ADDENDUM NO. 1

Project: ITB #26-19: Water Station 1 – Wellhouses 3B & 5B

Date: May 12, 2026

**WATER STATION 1 (2103 RESERVE St.)
NORTHSIDE SITE MAP**

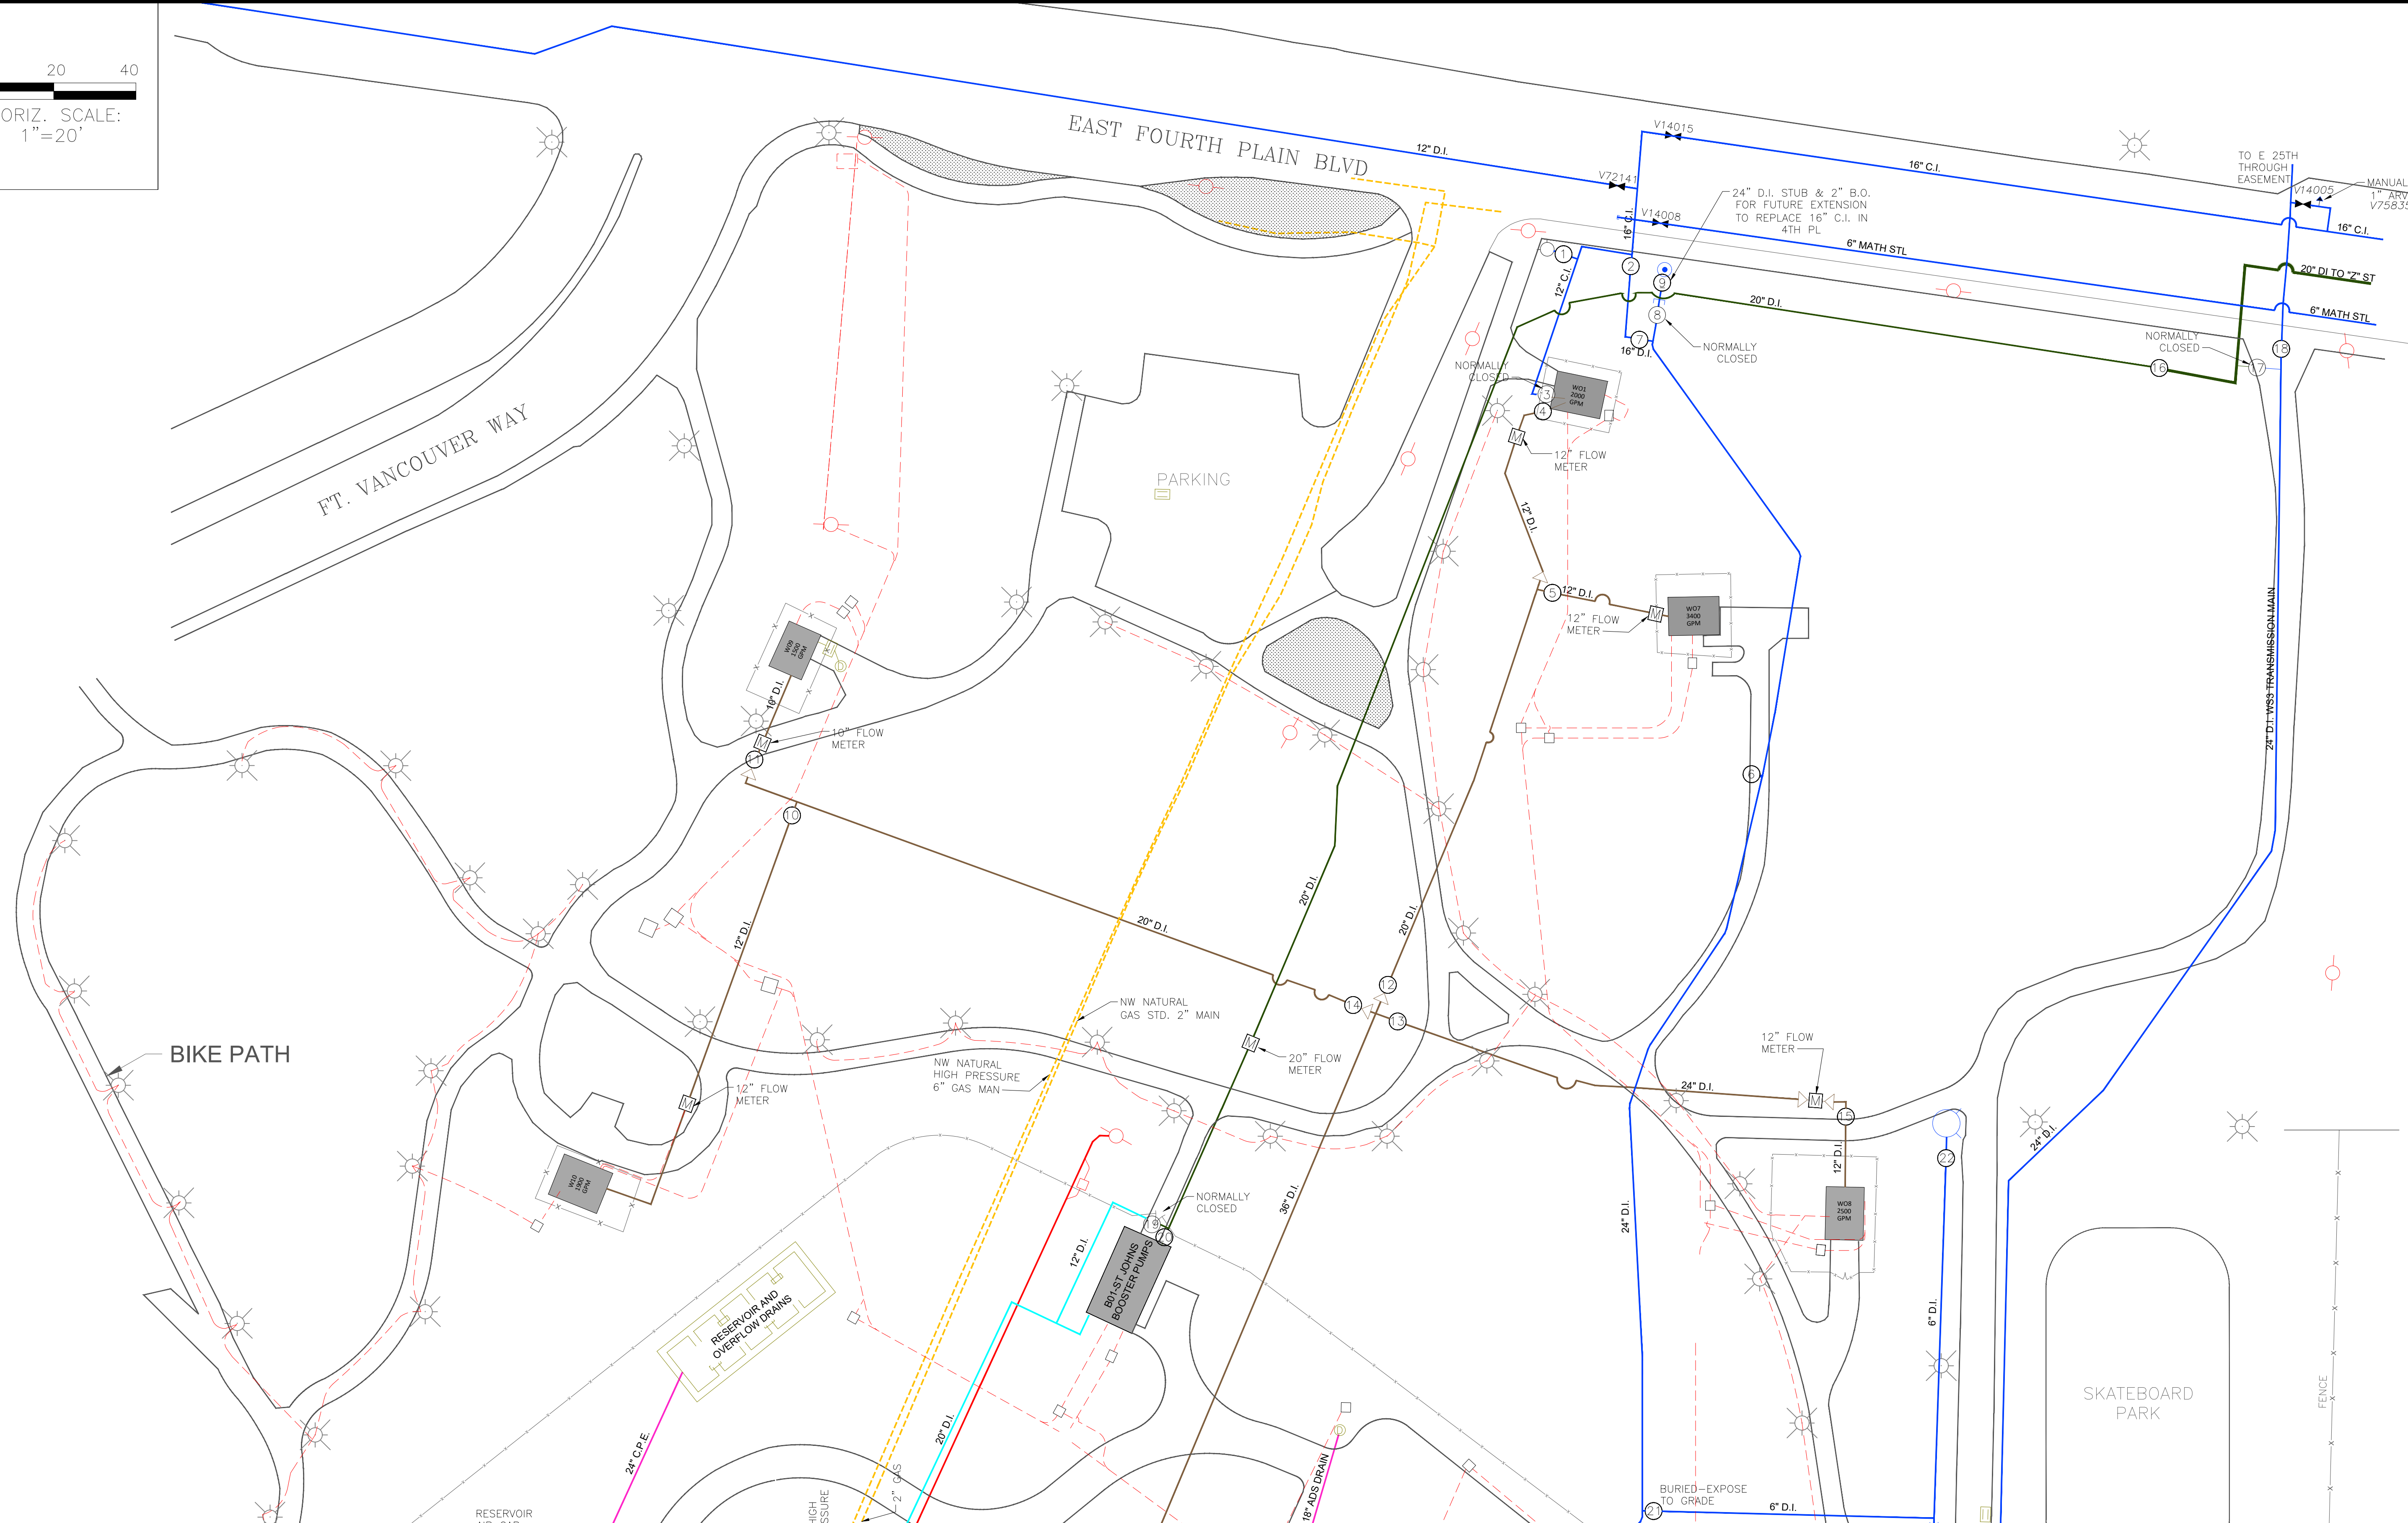
Q4: Can the City provide as-builts?

A4: The attached site map(s) provided as a reference only for planning purposes.
